Our Ref: 23485_GRSF_Response to RFI Letter_V02_Final

5 April 2024

RE: Goulburn River Solar Farm - Response to DPHI RFI dated 31 January 2024

Appendix B Existing BAR Turn Path Assessment

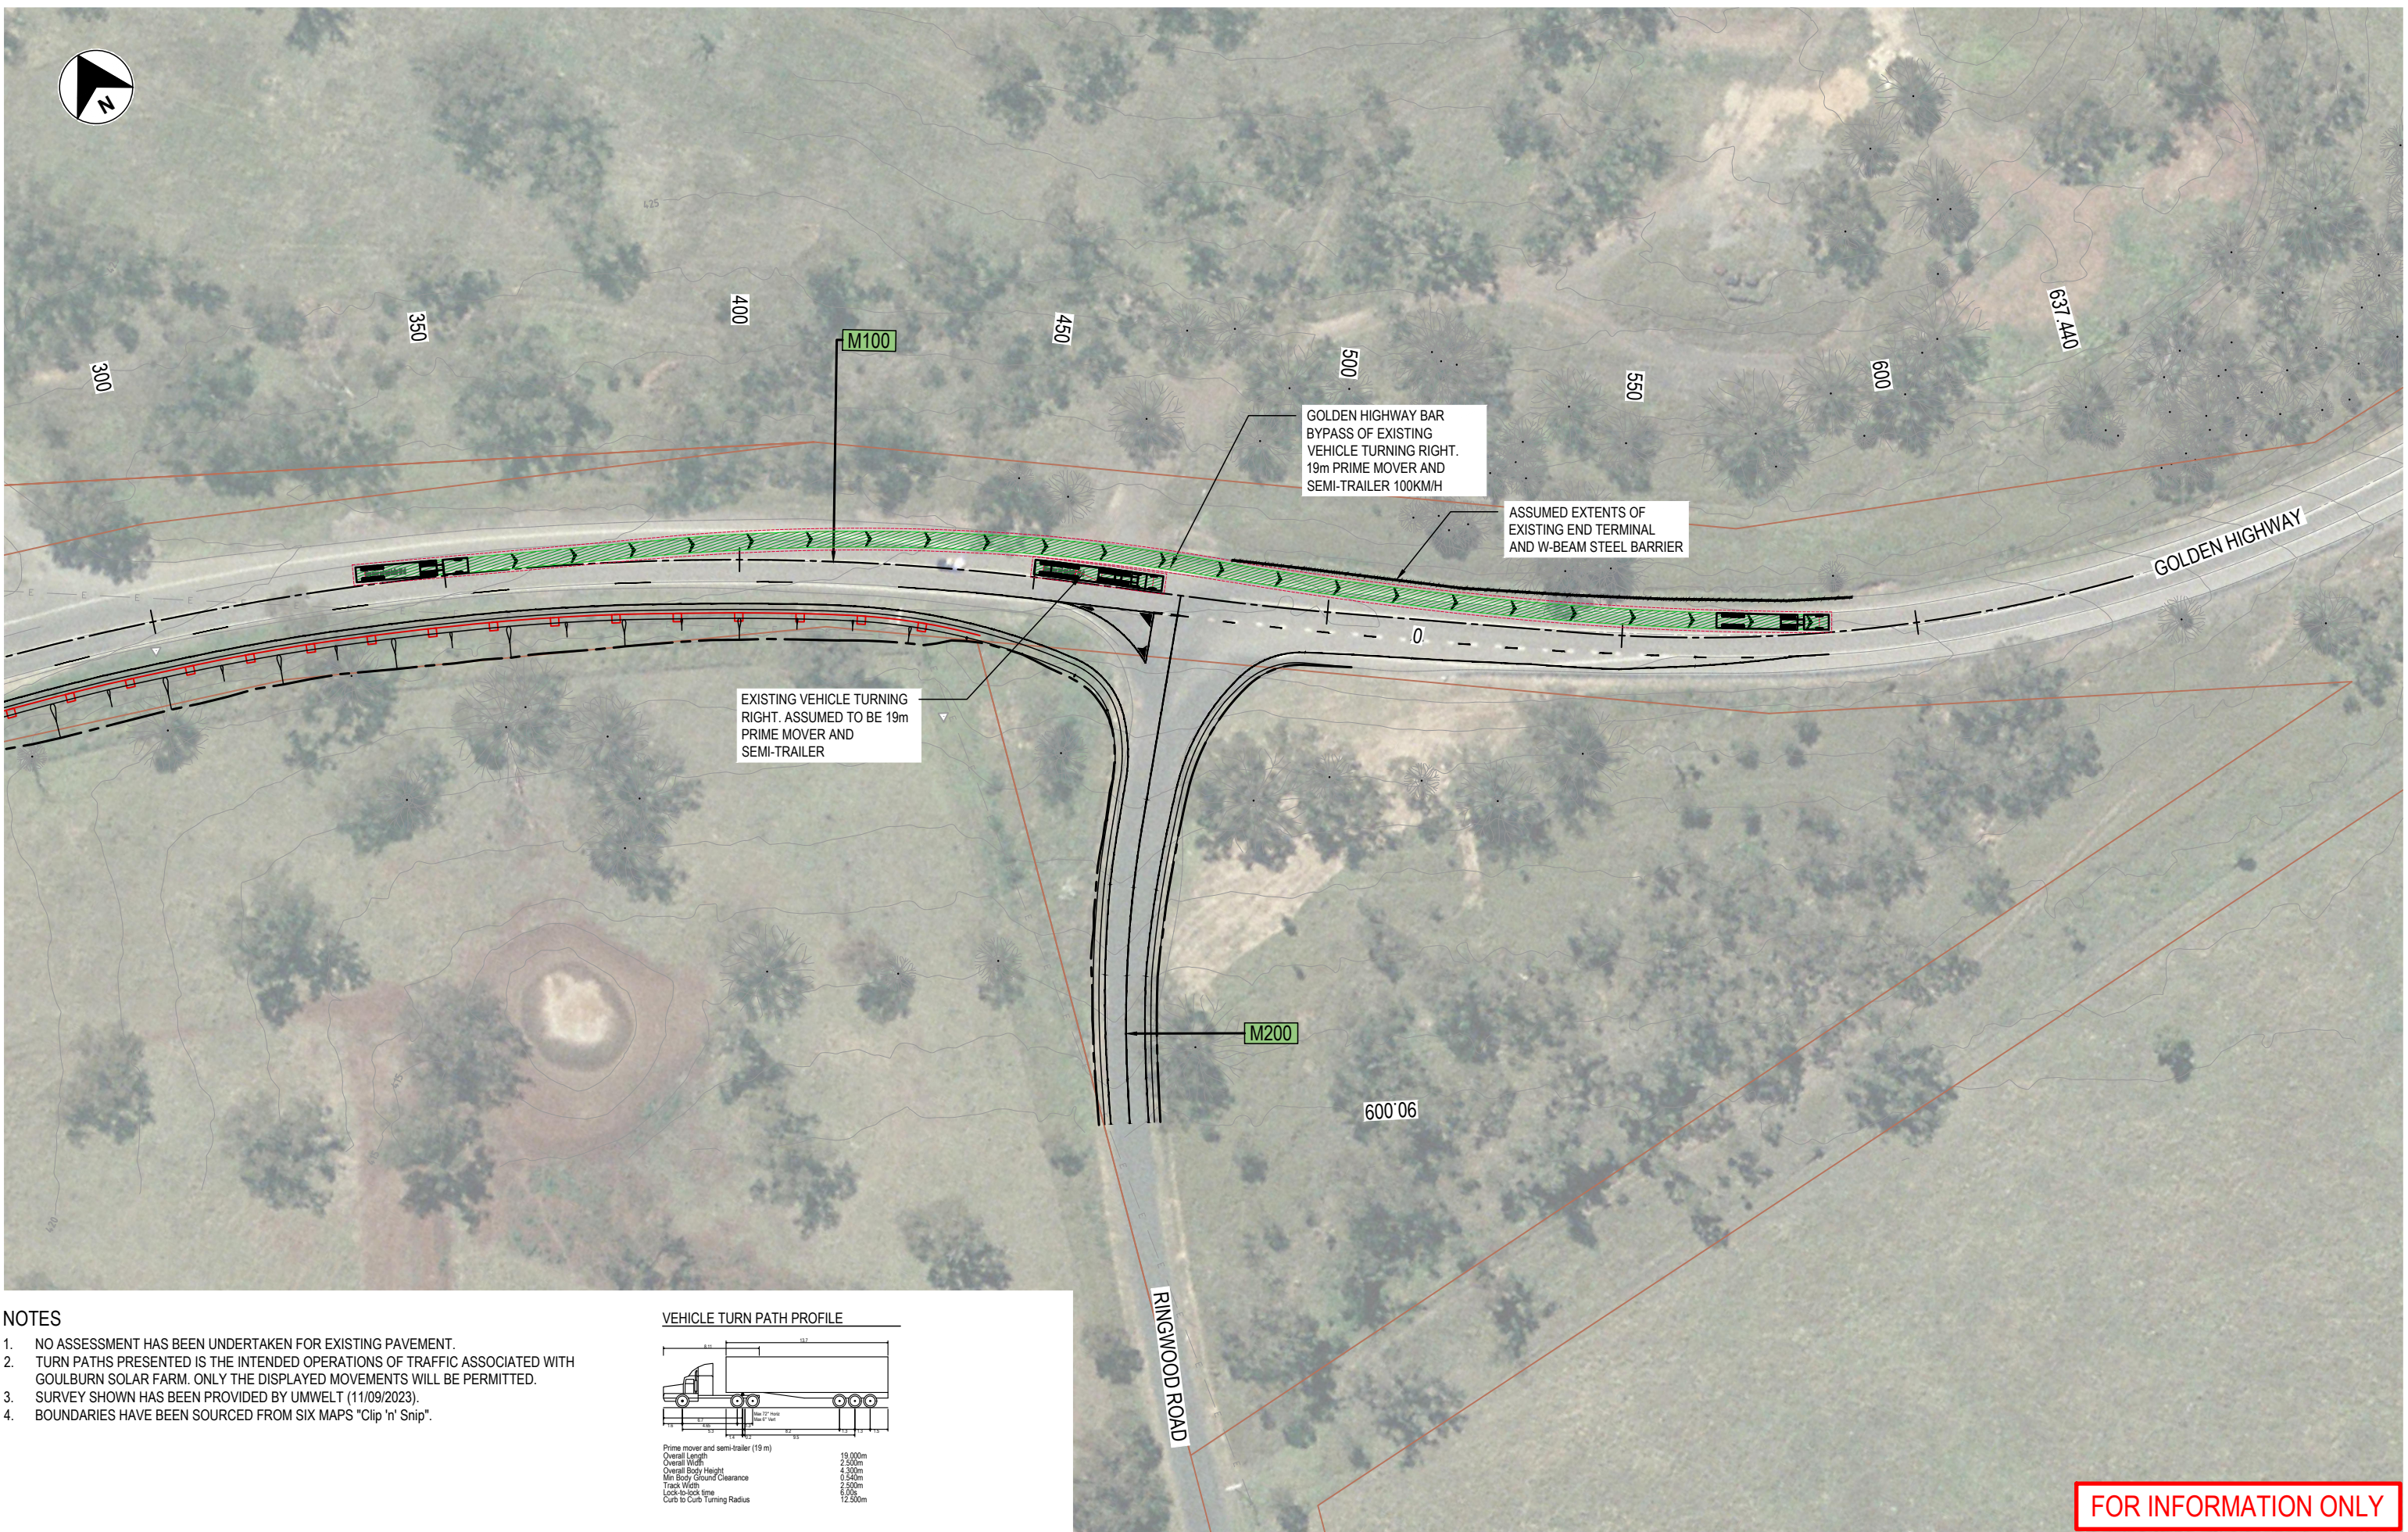
TfNSW also requested the preparation of a Turn Path Assessment for the existing BAR for right turn movements at the Golden Highway onto Ringwood Road. The turn path assessment is included in **Appendix A** of this letter and is summarised below.

The Goulburn River Solar Farm design vehicle (i.e. a 19 m prime mover and semi-trailer) has been assessed as able to utilise the existing BAR facility to bypass a 19 m prime mover and semi-trailer (non-Project related design vehicle). Due to the existing design of the intersection, the design vehicle would however be within the shy line of the barrier and end terminal.

Whilst this meets design requirements, it is not the most optimal outcome with respect to vehicle safety. As such, Lightsource bp are proposing additional works to alter the existing barrier and end terminal currently in place at the intersection, to ultimately improve the safety of road users. Lightsource bp propose to relocate the safety barrier approximately 2 m to the east from the existing starting position, which would continue for approximately 35 m south, lining back up with the existing barrier location. This would provide additional space to allow a vehicle to safely overtake a vehicle waiting to turn right onto Ringwood Road. The alteration of the safety barrier would require an extension of the existing road pavement to the altered barrier, creating a disturbance area of approximately 51.3 m². The location of the proposed safety barrier alteration, and extent of the safety barrier disturbance area, are presented in **Figure 2.1** below.
